CITY OF ALBUQUERQUE

RE: **Broadstone Highlands Hotel Block**
Grading and Drainage Plan
Engineer's Stamp Date: 2/1/18
Hydrology File: K15D034B

Based on the information provided in the submittal received on 2/2/18 the above-referenced Grading and Drainage Plan cannot be approved for Site Plan for Building Permit until the following are corrected:

GRADING
& DRAINAGE PLAN

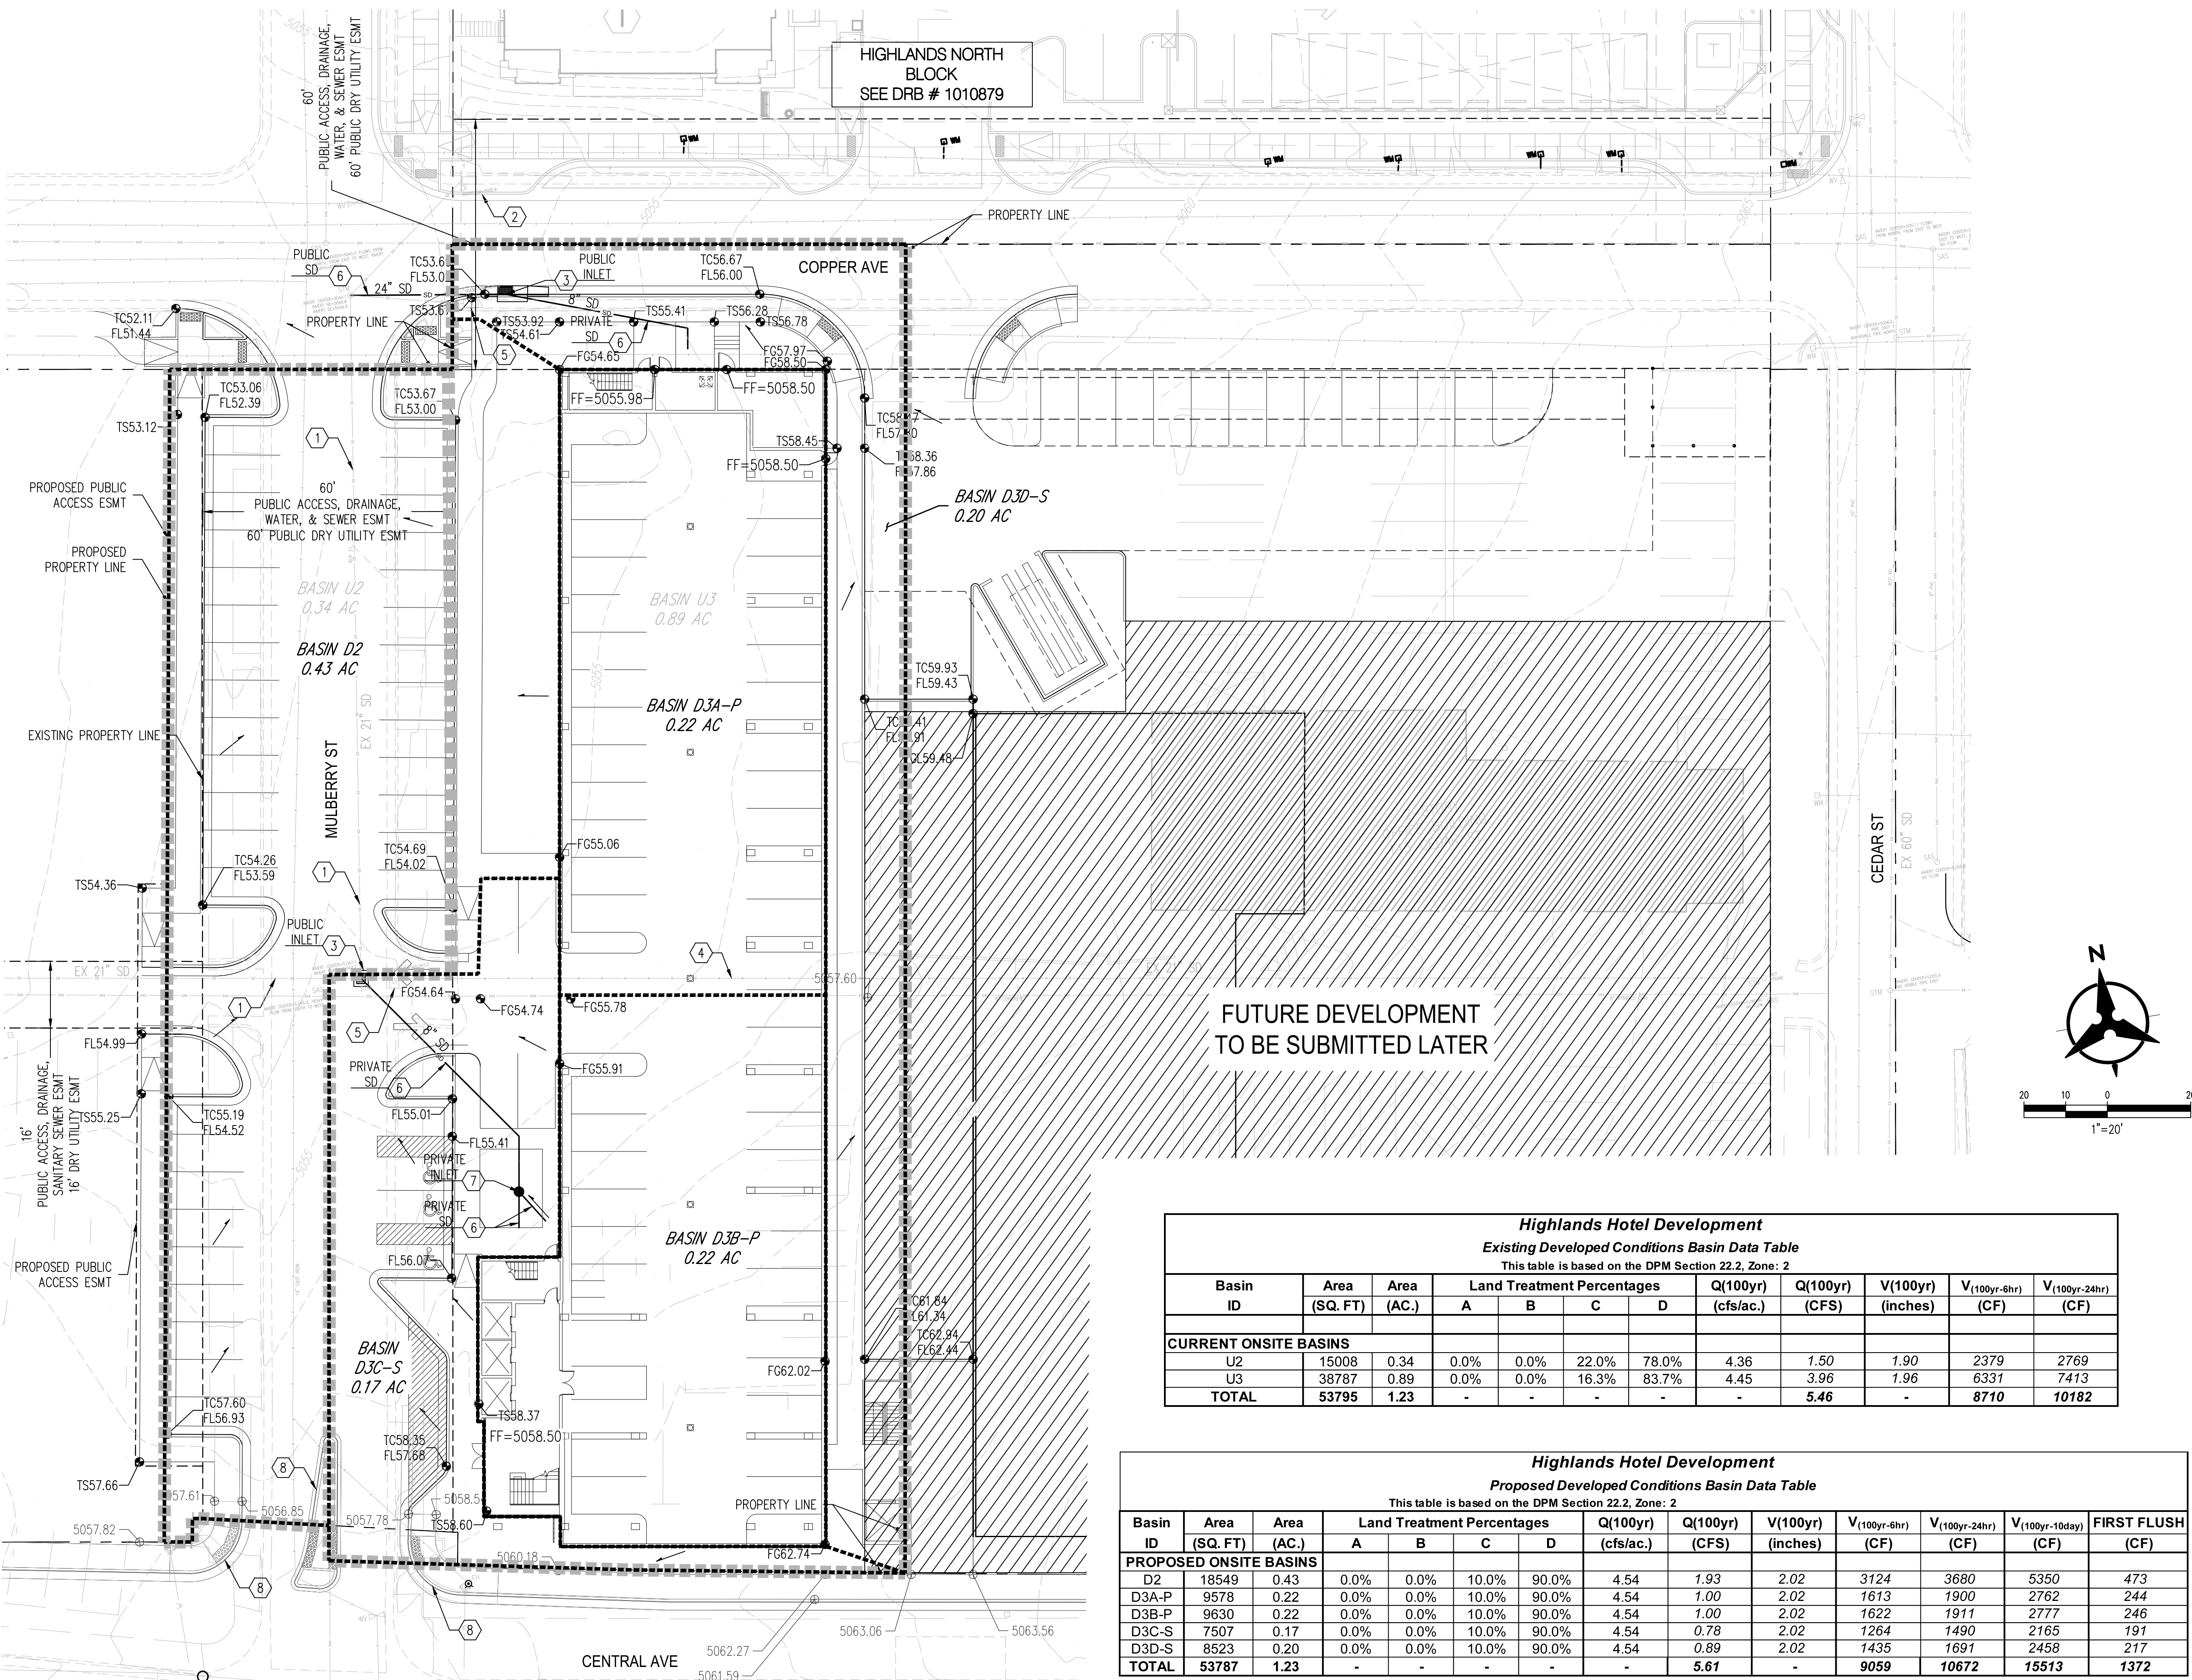
1. At the intersection of vacated Mulberry and the alley, provide a clearly defined waterblock, 1' high, to prevent flows from leaving Mulberry and flowing west down the alley.

2. Clarify the work to be performed on the public and private storm drain at the intersection of vacated Mulberry and the ally. Currently there is a public manhole in the street and a public type-D inlet in the flowline. Will the manhole be replaced with a new inlet, with the street graded towards it? The new inlet does not appear to be placed where it will intercept flows.

3. Provide additional flowline elevations at the intersection of vacated Mulberry and Central. Is there anything here to keep flows from entering your site from Central?

4. Provide a copy of the recorded easement for the 21" public storm drain passing under the hotel. The original recorded easement will also need to be turned into DRC-Construction Services (Madeline Carruthers, 4th floor, Plaza del Sol) prior to any DRB action.
